Joint response of Suffolk Coastal District Council and Suffolk County Council to EDF Energy's Stage 3 Public Consultation

March 2019

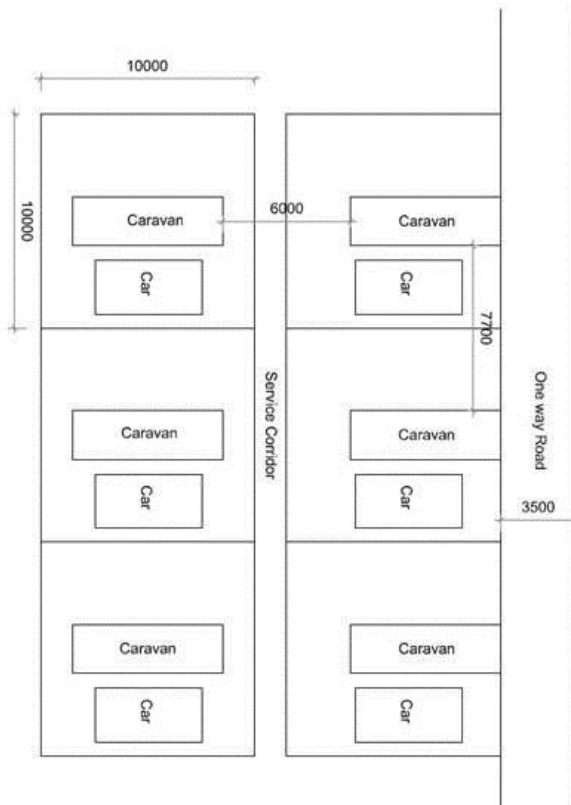
228. To consider the acceptability of an increase of the workforce number beyond 5600, the Councils expect deliverable and enforceable mitigation proposals, to avoid or mitigate impacts on the local housing market.

Stockpiling

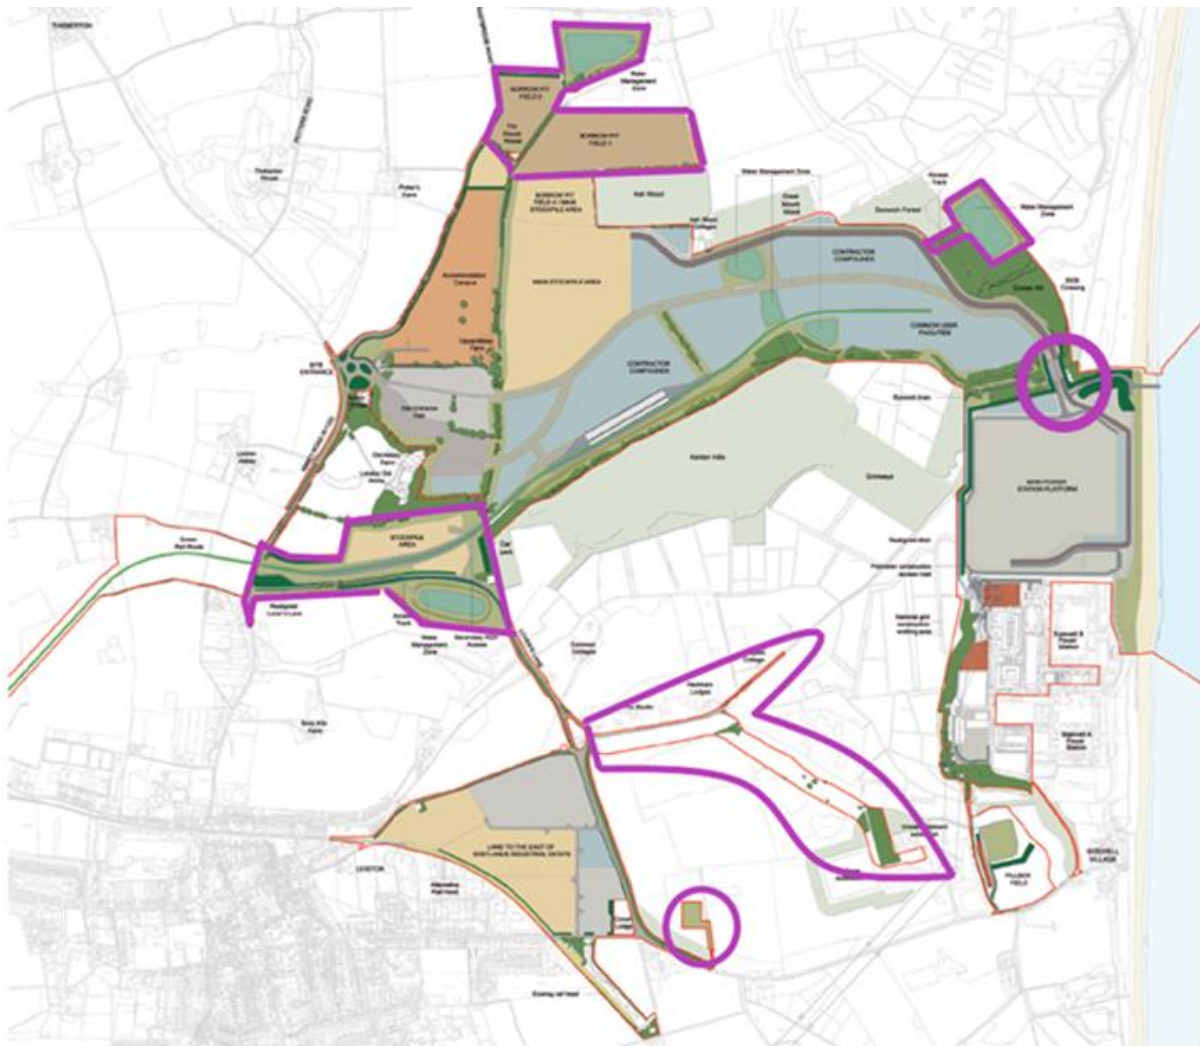
616. The main stockpile area will be on land to the east of Bridleway 19 and at its maximum will be up to 35 metres high – it is likely to reach this peak a few years into construction and will then reduce. It would have access ramps of 1:8 and a plateau working area on top.

617. Other stockpiles will be between 3.5m - 11m – 15m at peak height. The stockpile on the LEEIE may be up to 15m, HGVs will transport material from the LEEIE to the main construction site. There will be landscaping of the borrow pit and stockpile areas.
